BYRD BARR
PLACE
RENOVATION

CA SET

Drawn by:	AC
Checked:	AH
Date:	06.23.2021
Scale:	As indicated
Revisions:	Remarks
No. Date	Landmarks Review
41 12/15/21

EXTERIOR
ELEVATIONS
A3.0

Item #1: Historic Light Fixtures

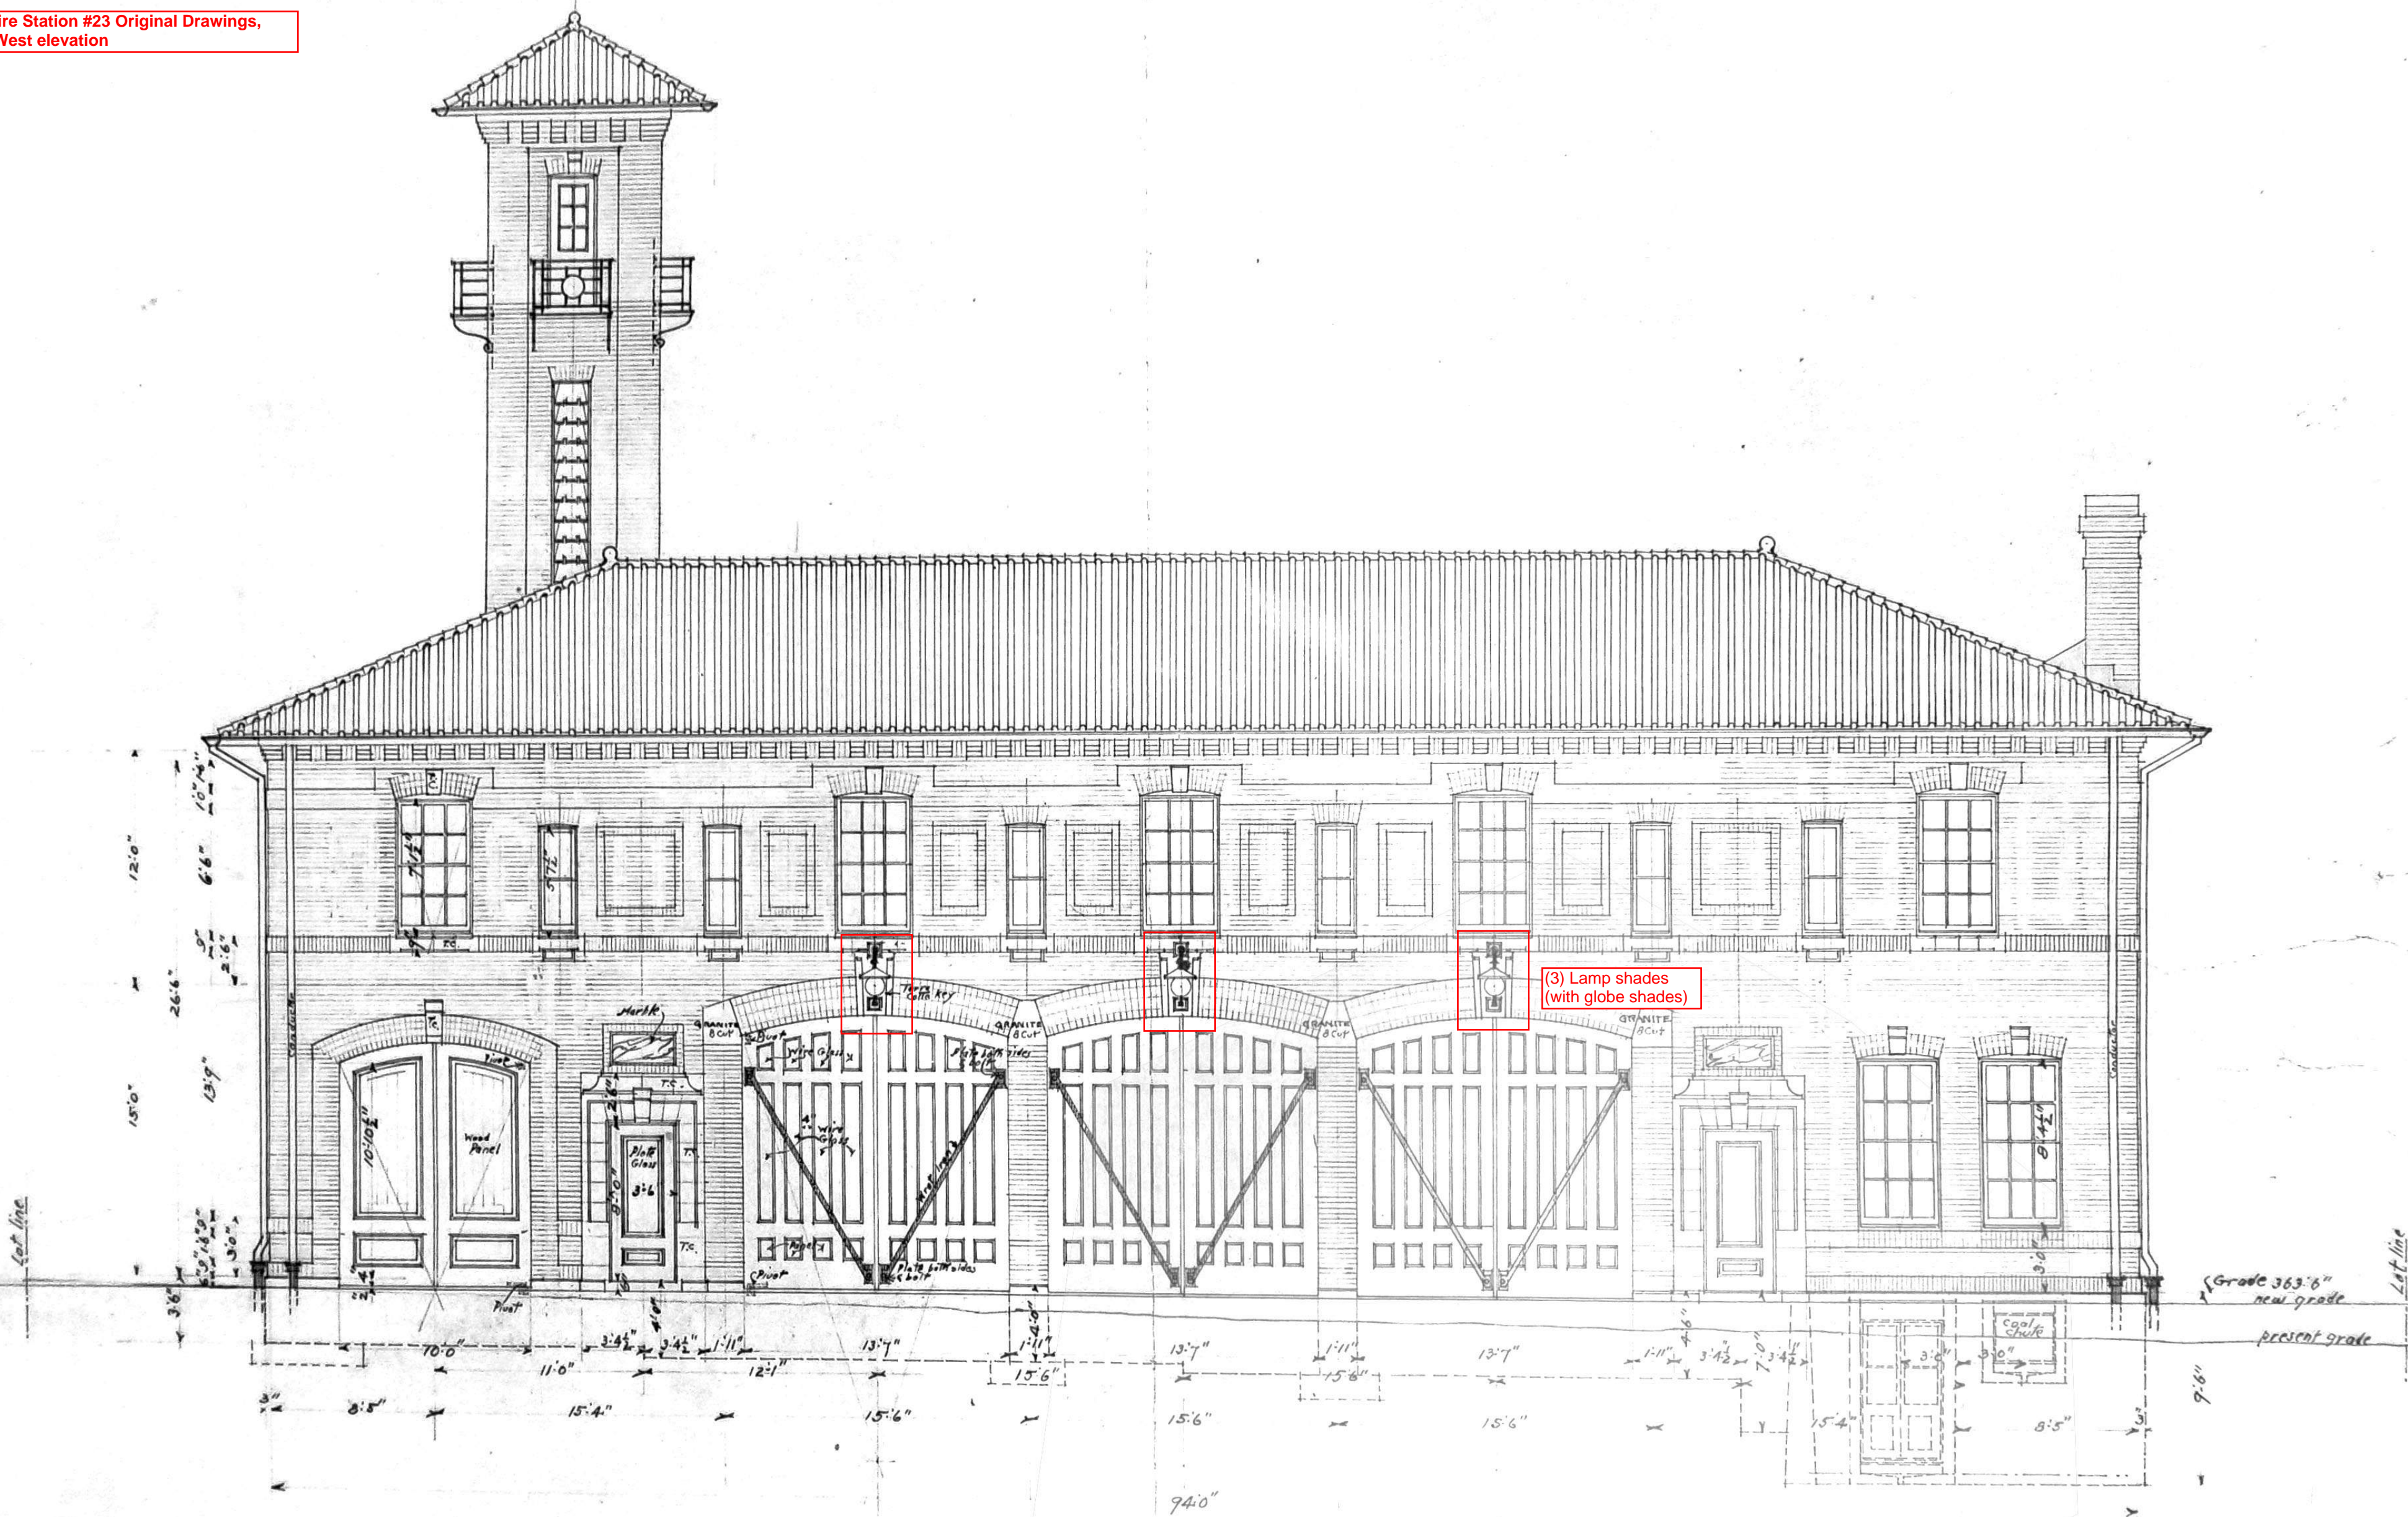
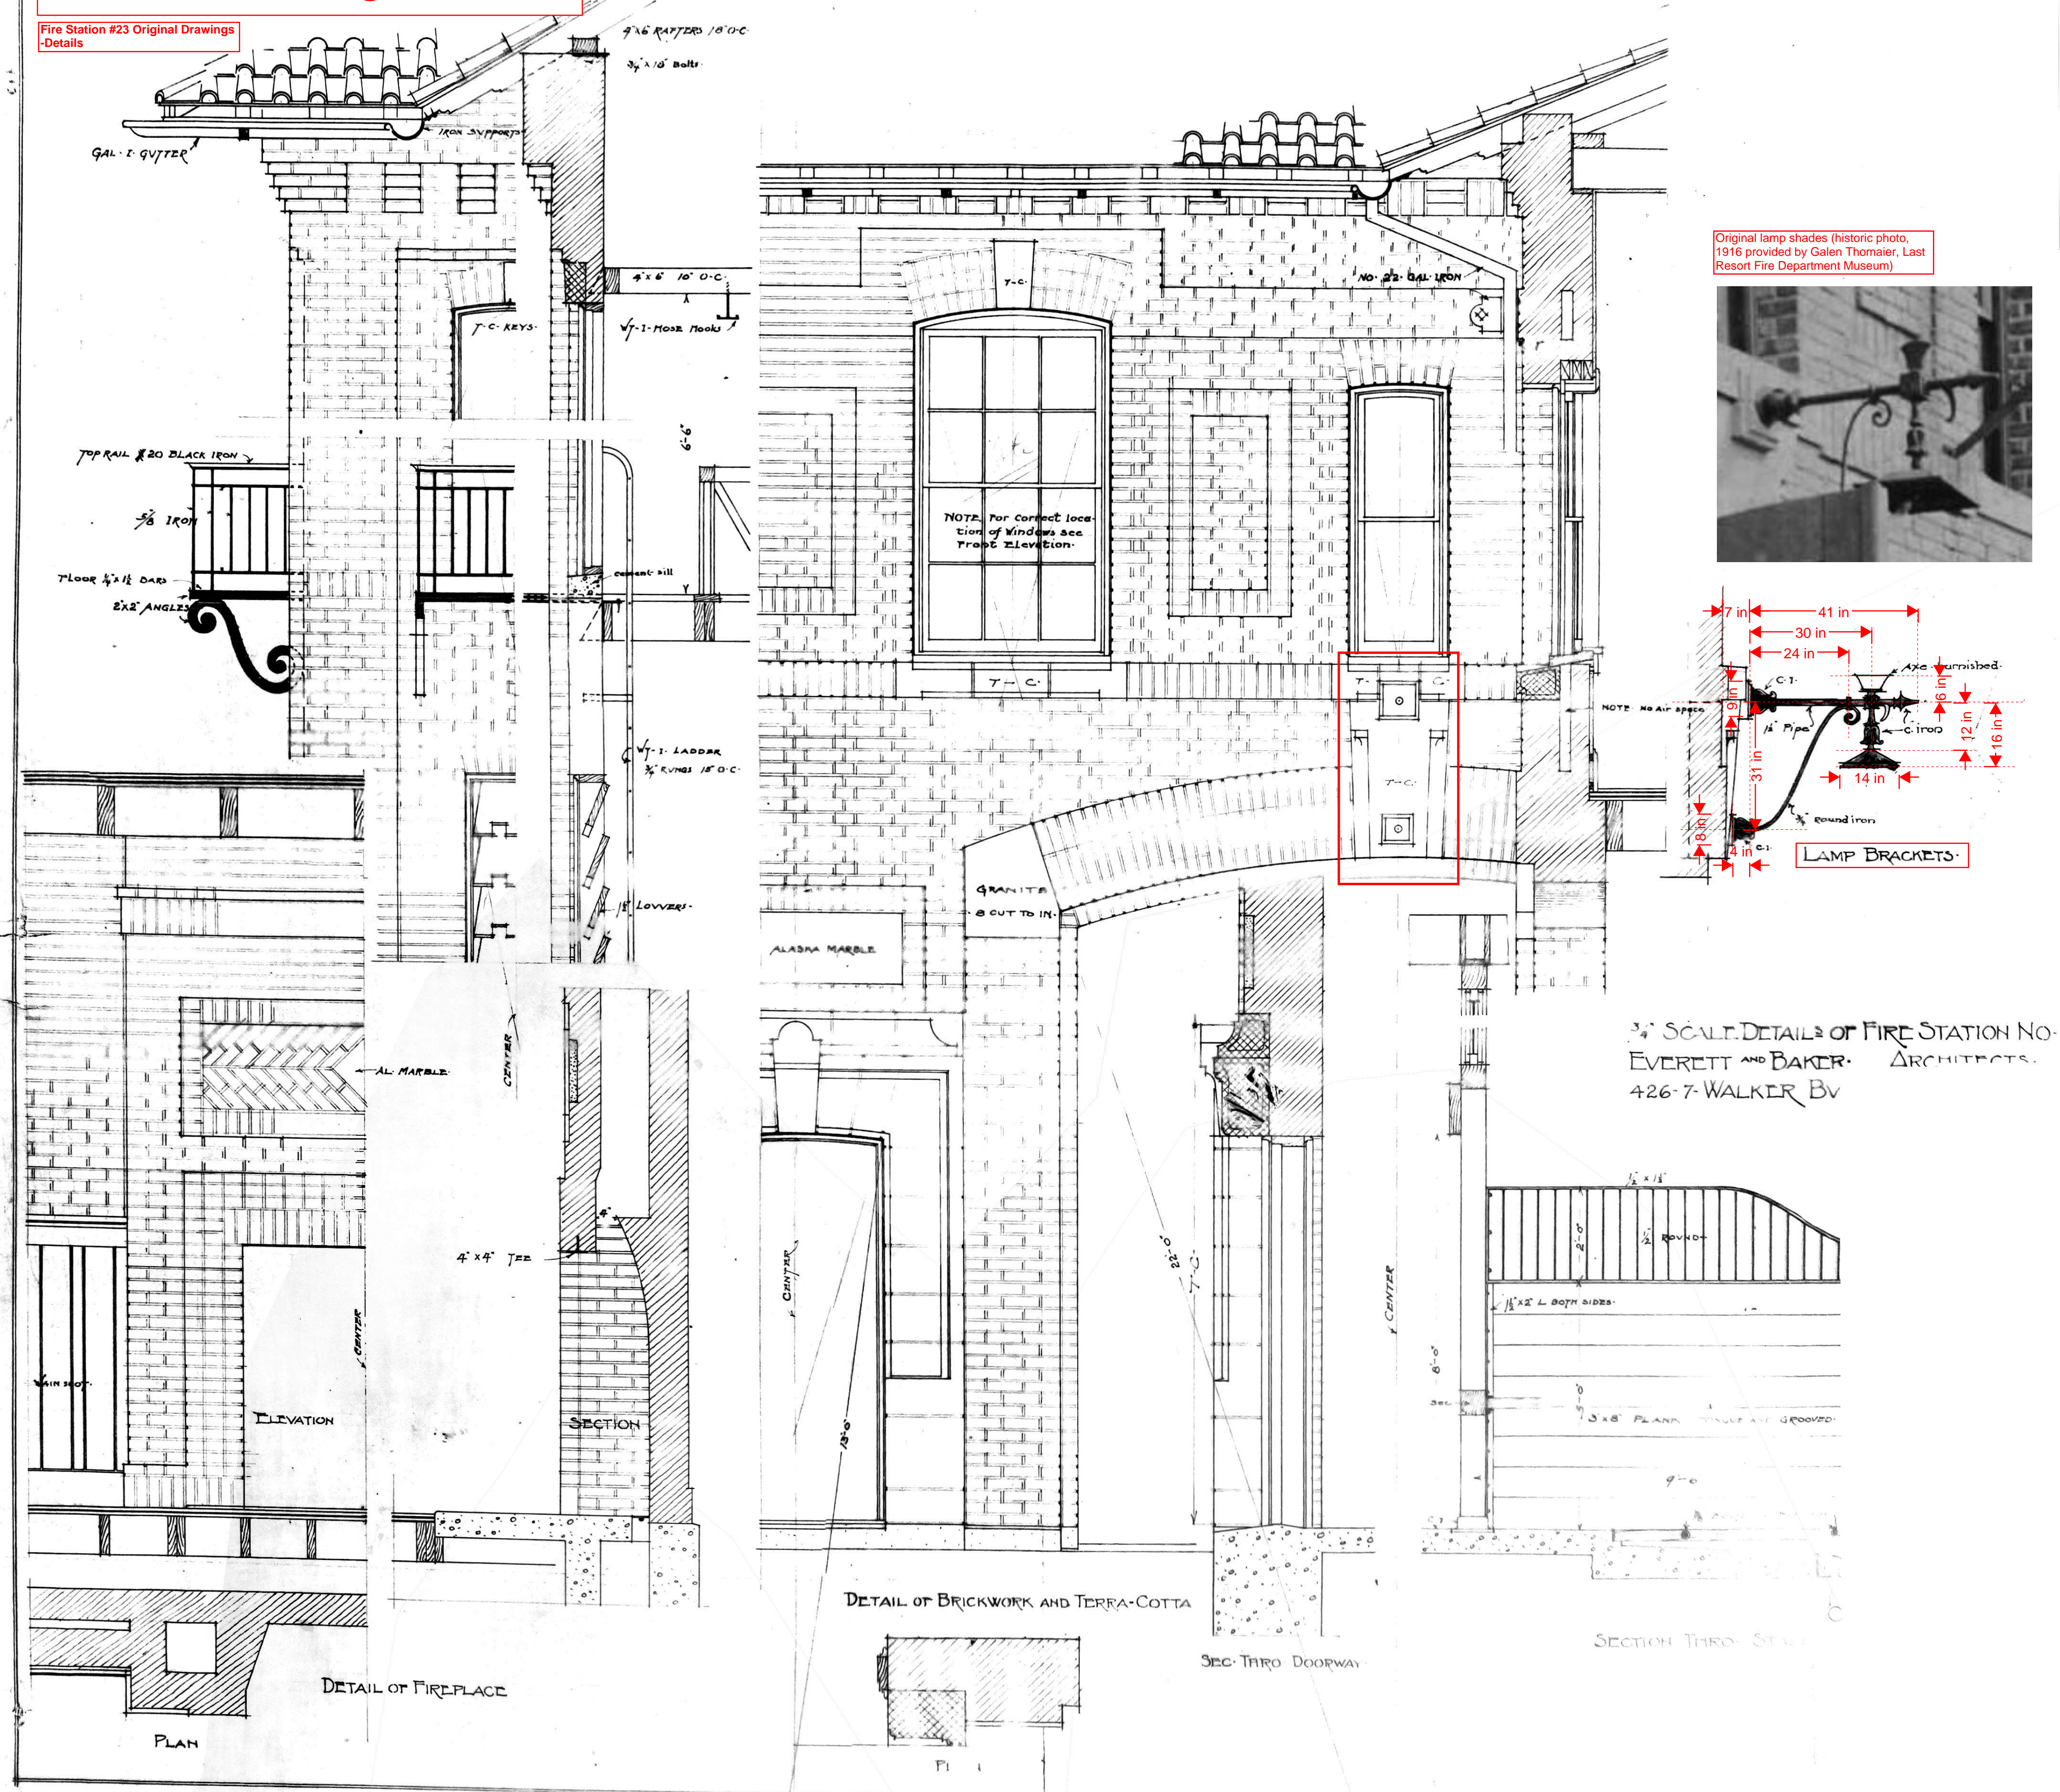
Existing Condition, West Facade
(no original fixtures remaining)

Fire Station #23 Original Drawings,
-West elevation

Fire Station #23 Original Drawings -Details

Proposed fixture design

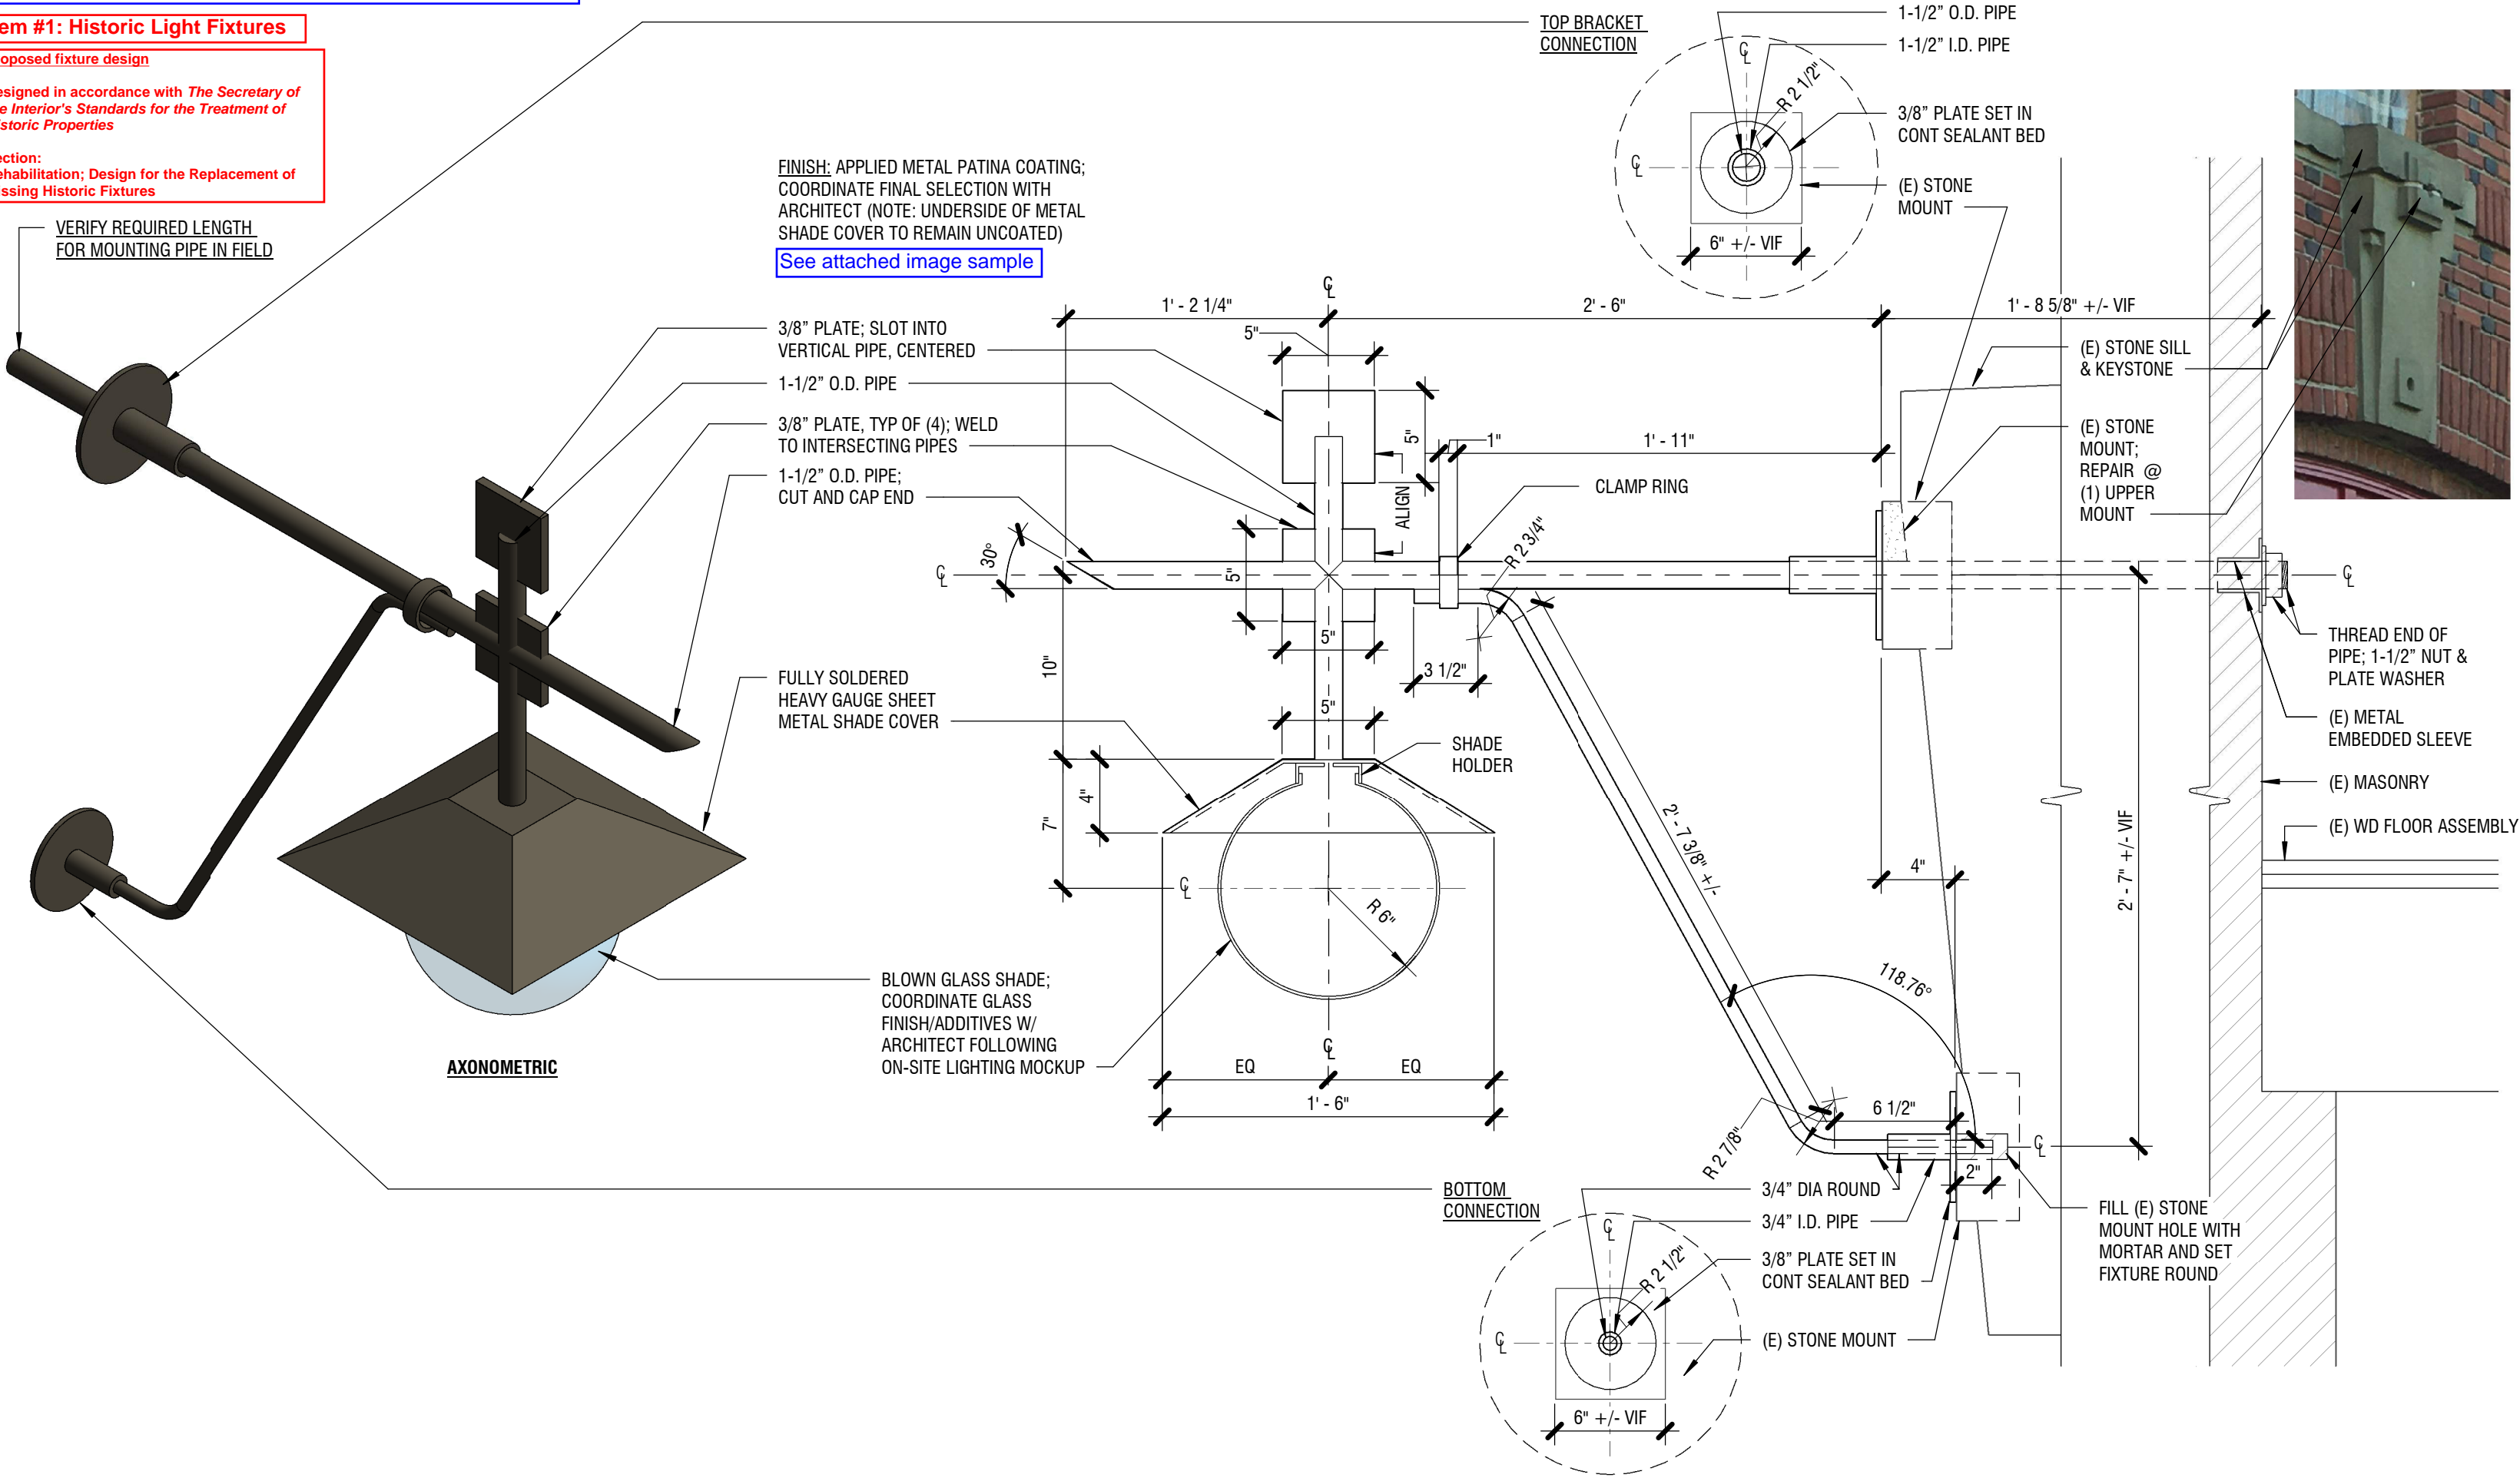
Item #1: Historic Light Fixtures

Designed in accordance with *The Secretary of the Interior's Standards for the Treatment of Historic Properties*

Section:
Rehabilitation; Design for the Replacement of Missing Historic Fixtures

FINISH: APPLIED METAL PATINA COATING;
COORDINATE FINAL SELECTION WITH
ARCHITECT (NOTE: UNDERSIDE OF METAL
SHADE COVER TO REMAIN UNCOATED)

VERIFY REQUIRED LENGTH
FOR MOUNTING PIPE IN FIELD
